ADDENDUM NO. 2

Contract No. 2023-0050
Project Southeast Municipal Complex

Date of Issuance 09/19/2024

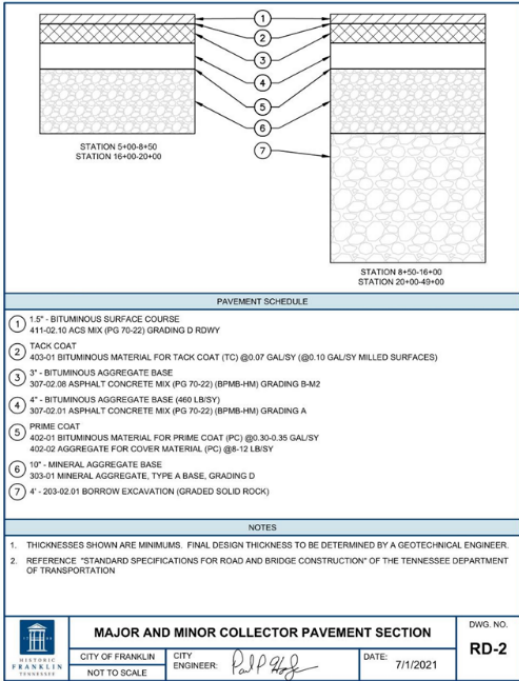
Q50	Question: Item #46 on C2.1C calls for a synthetic turf manhole cover on an existing sanitary sewer manhole within the limits of a future field 9. Confirm this manhole cover will not need to be replaced with this contract.
A50	Answer: The existing manhole covers do not need to be replaced, however the existing manholes on future fields 6, 7, and 9 will need to be adjusted up to meet the proposed grades as a part of this contract.

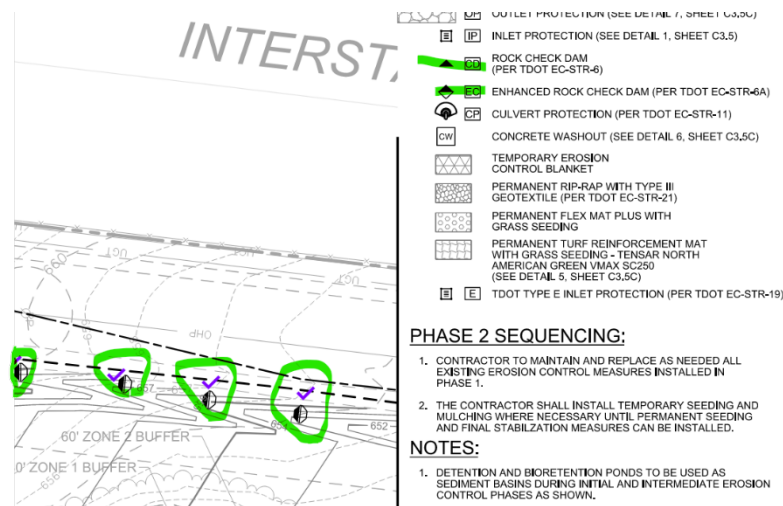
Q69 **Question:** Structure CB-156 is in the Path of 2" Water Service for Playground, use 45* Bends to bypass?

A69 **Answer:** Yes, use bends to avoid structure.

MB-A6.42 WALL SECTION
 Autodesk DWG TO PDF Converter
 File Name: 19122024_143331.dwg
 Date: 11/22/2024 1:43:31 PM

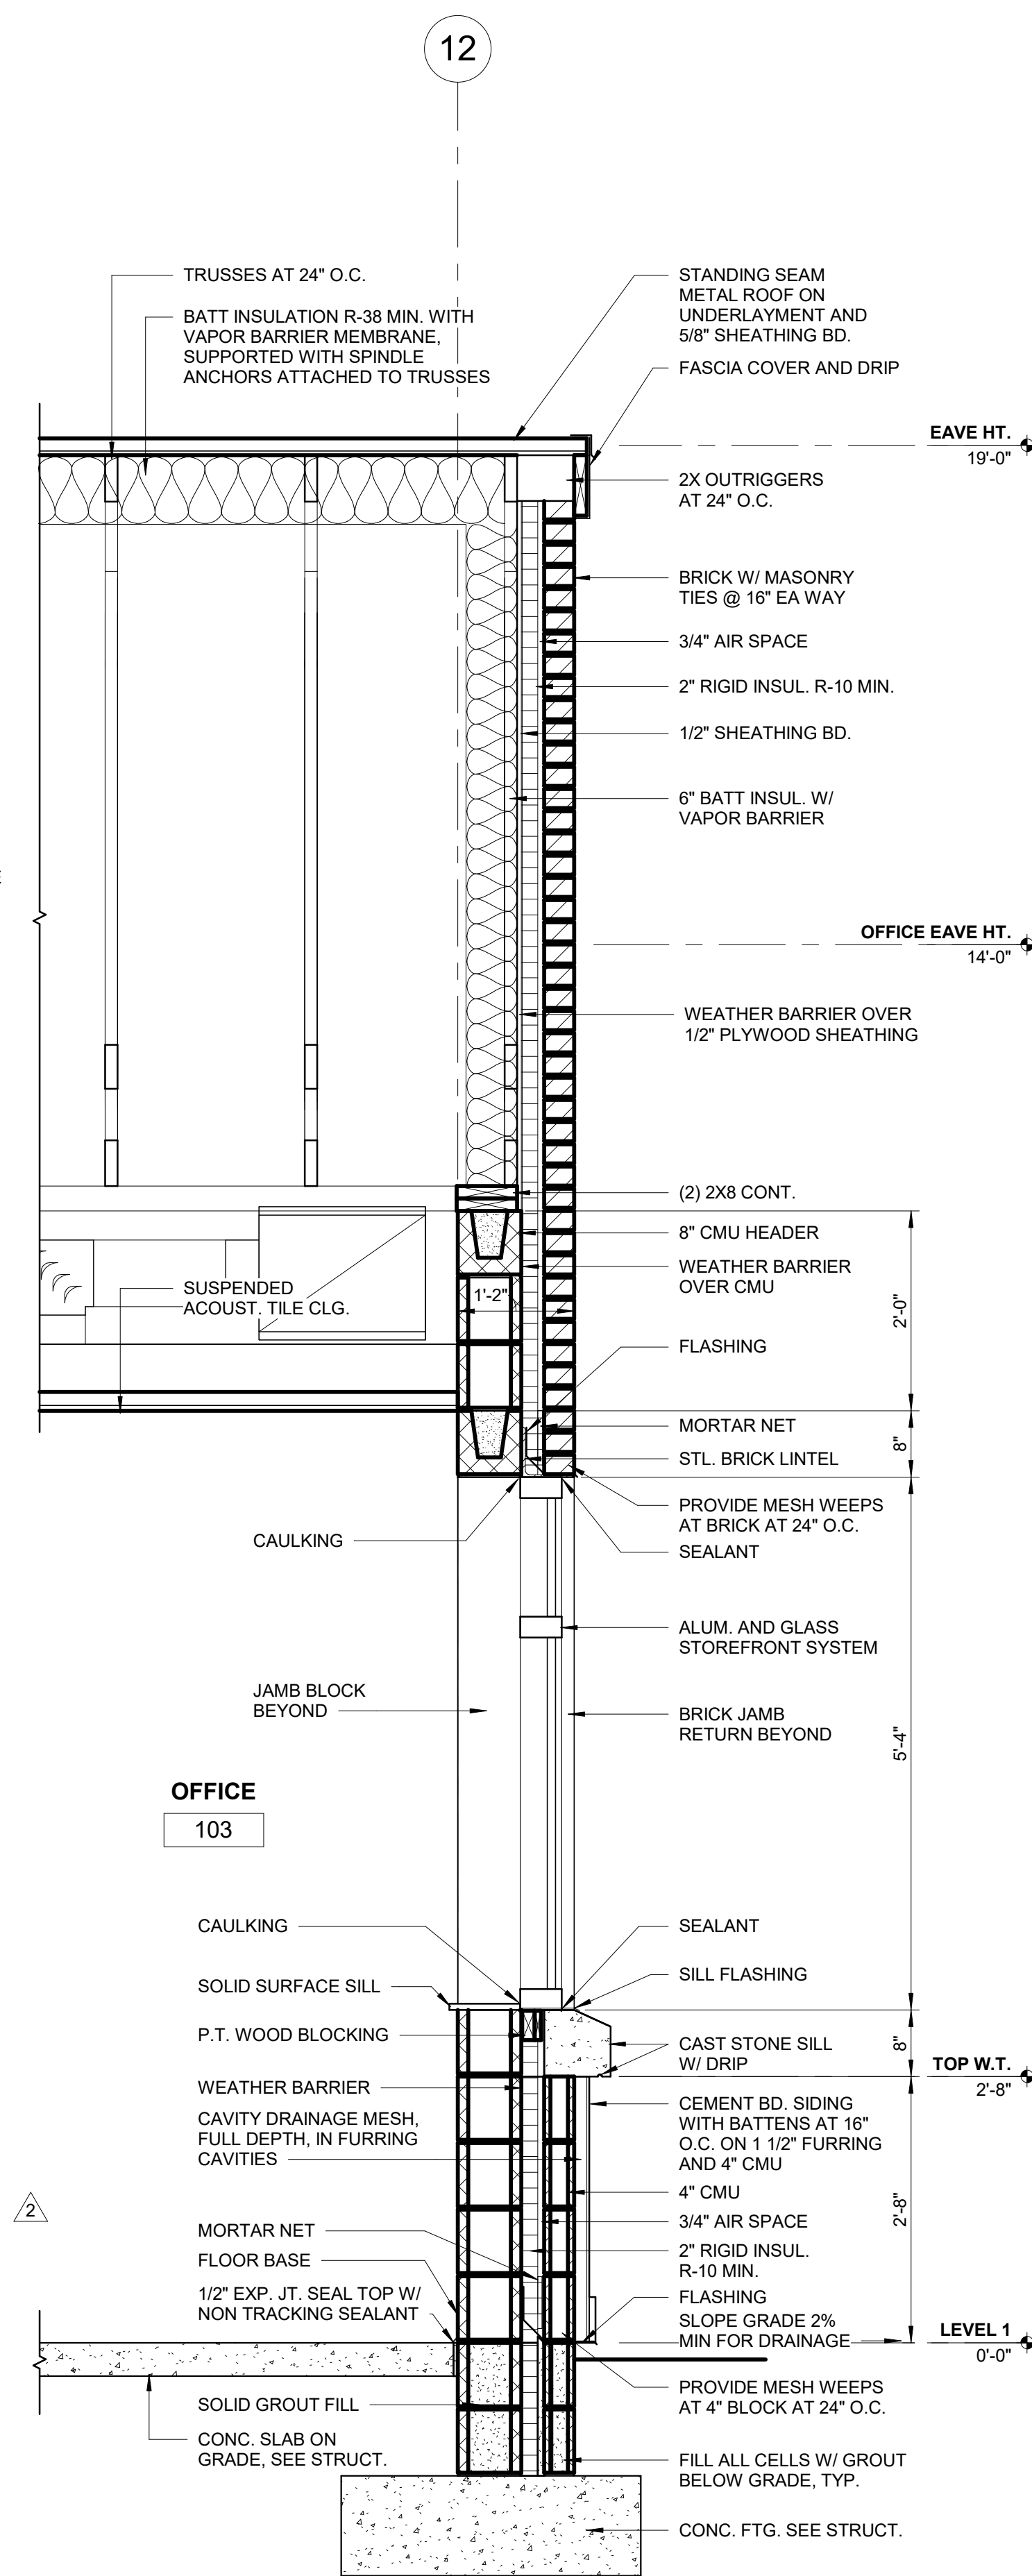
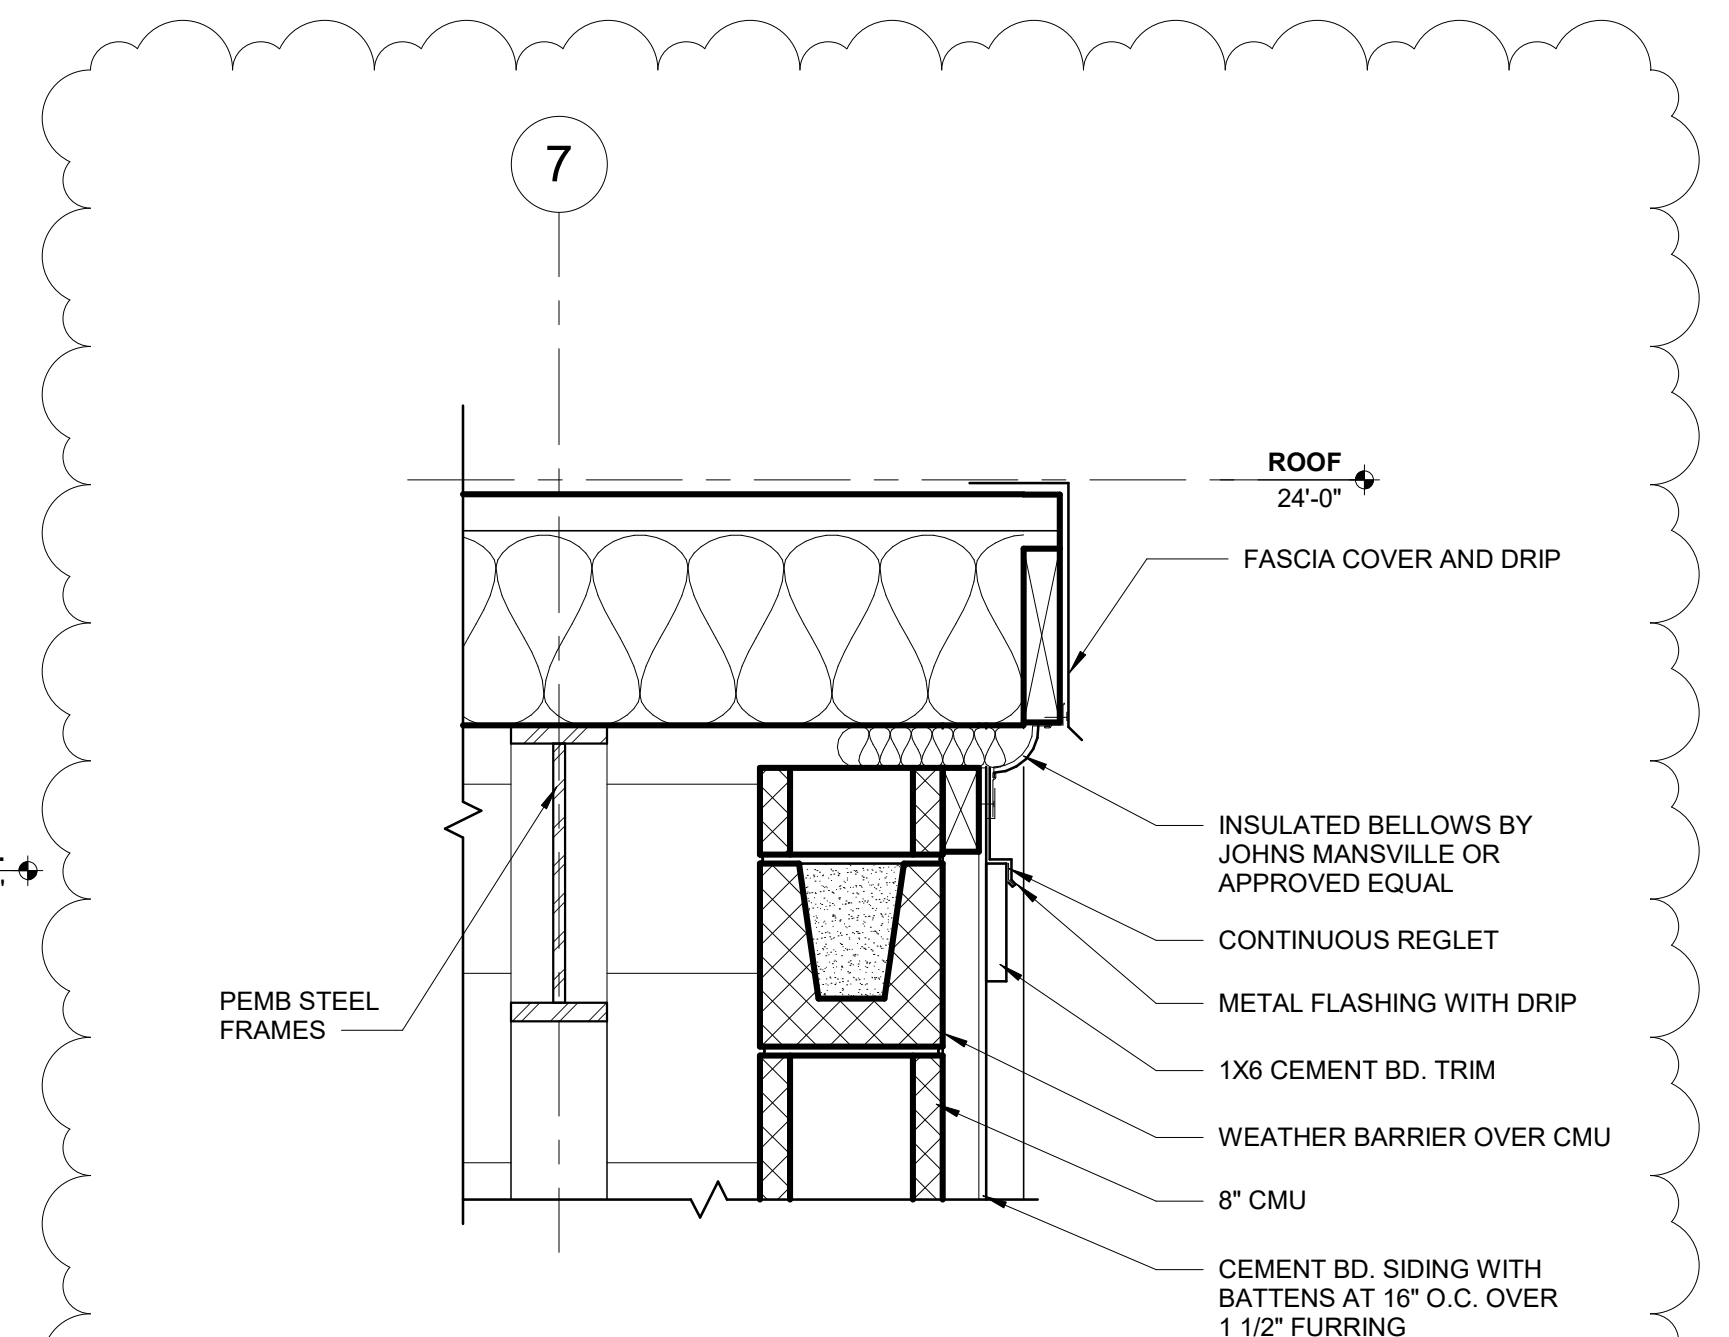
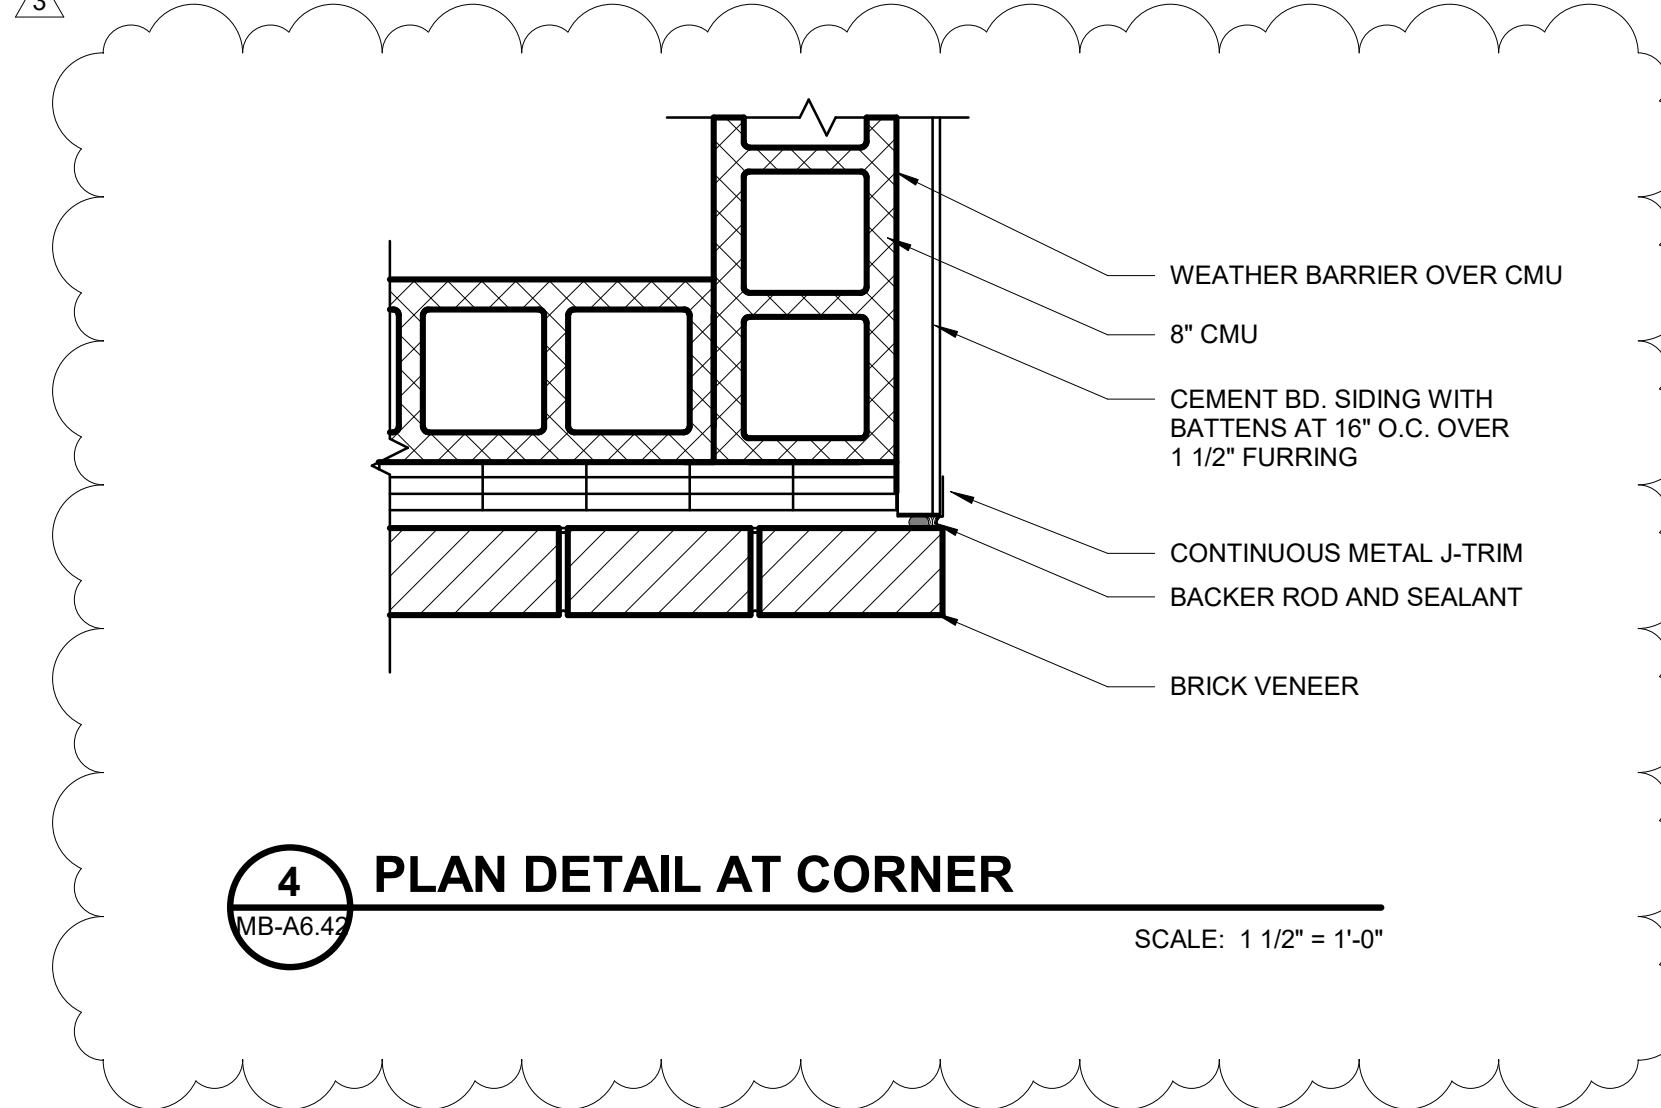
- i. Plans Drawing **MB-A6.42, Wall Sections**, for the **Maintenance Building** has been updated and provided as **Attachment I** in response to Question 56.

Q56	Question: Please clarify if an expansion joint in Maintenance Building, between the PEMB and conventional construction of the building, is required. Ref 2/MB-A6.42
A56	Answer: See revised drawings included in addendum 2.
Q57	Question: 6" detached concrete curb shown on C4.3A is shown as having a 4" base below the subgrade elevation of the asphalt pavement. Will it be acceptable to use a 12.5" curb (6" above grade, 6.5" below grade) to match the subgrade elevation across the curb and pavement.
A57	Answer: The 6" detached concrete curb detail is COF standard detail.
